CONCESSION					TN-006542186
					С
Drawing N°	V53274210			Revision	
Part N°	V53274210012	Quantity	1	Page	1 of 2
Part Description	SSRH CDS INSTL			A/C Type	A350-900
Item SN	N/A	CA code and s/n	WG540/TN10807	MSN	00795
		Responsible Design Office Decision		Attached documents	2 pages

Description of Divergence

CONCESSION CONTINUATION SHEET

1

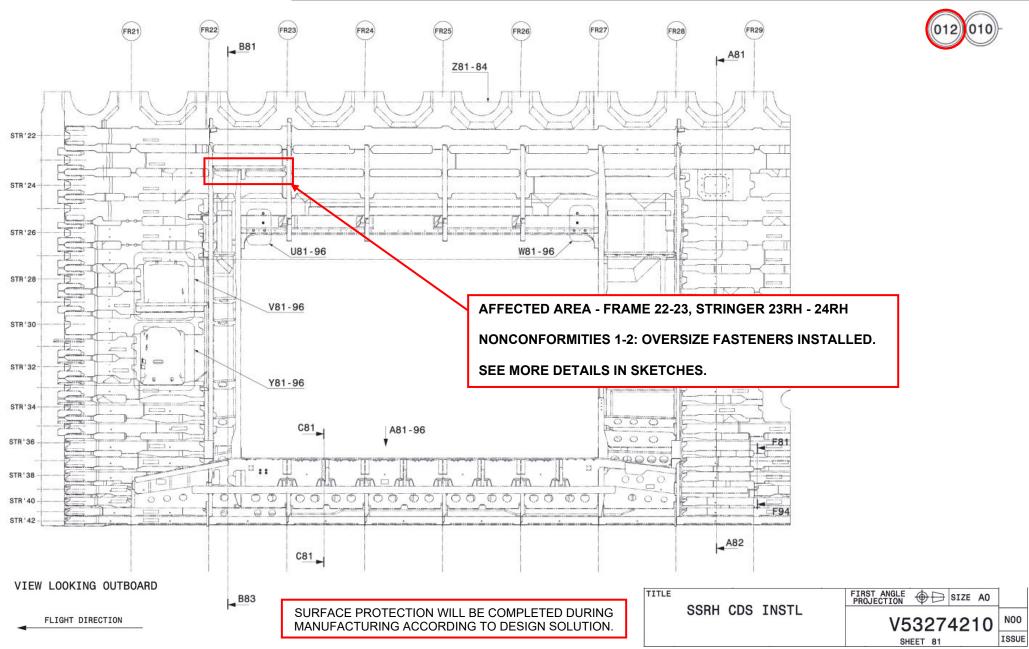
NonConformity 0001:

Type of nonconformity: Oversized Hole

Drilled Hole Specification: ABS1707CC8V3A

NONCONFORMITY 1: OVERSIZE FASTENERS INSTALLED.

NONCONFORMITY 1: OVERSIZE FASTENERS INSTALLED.

NONCONFORMITY 2: OVERSIZE FASTENERS INSTALLED.

- Acceptable as is.

- Acceptable as is.

- C suffix due to fastener diameter 6,35mm being larger than 1/32in (0,8mm) of original diameter 4,76mm in contradiction with ASR A350-A-51-43-XX-01001-667A-A for NonConformity 0002.

Nonconformity is acceptable without limitations even if the limits in applicable in-service documentation are exceeded.

2

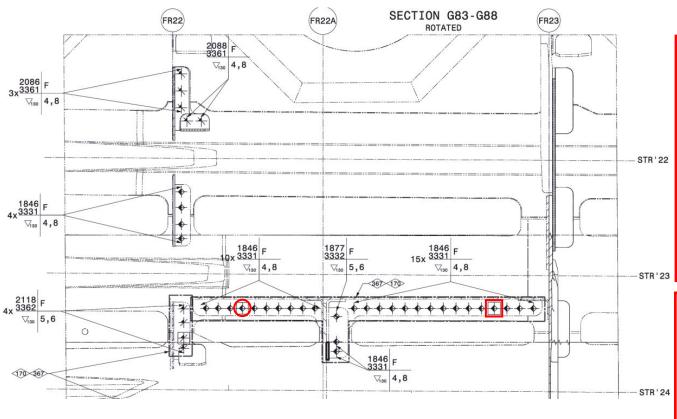
O NONCONFORMITY 1: 1x OVERSIZE FASTENERS INSTALLED

SHOULD BE:

HOLE CODE: ABS1707BC8V3A

FASTENERS: ASNA2041D3 + ASNA2045-3

IS:

HOLE CODE: ABS1707CC8V3A

FASTENERS: ABS0873B3AE + ABS1826K3A

NONCONFORMITY 2: 1x OVERSIZE FASTENERS INSTALLED

SHOULD BE:

HOLE CODE: ABS1707BC8V3A

FASTENERS: ASNA2041D3 + ASNA2045-3

IS

HOLE CODE: ABS1707DC8V3A

FASTENERS: ABS0873B4E + ABS1826K4
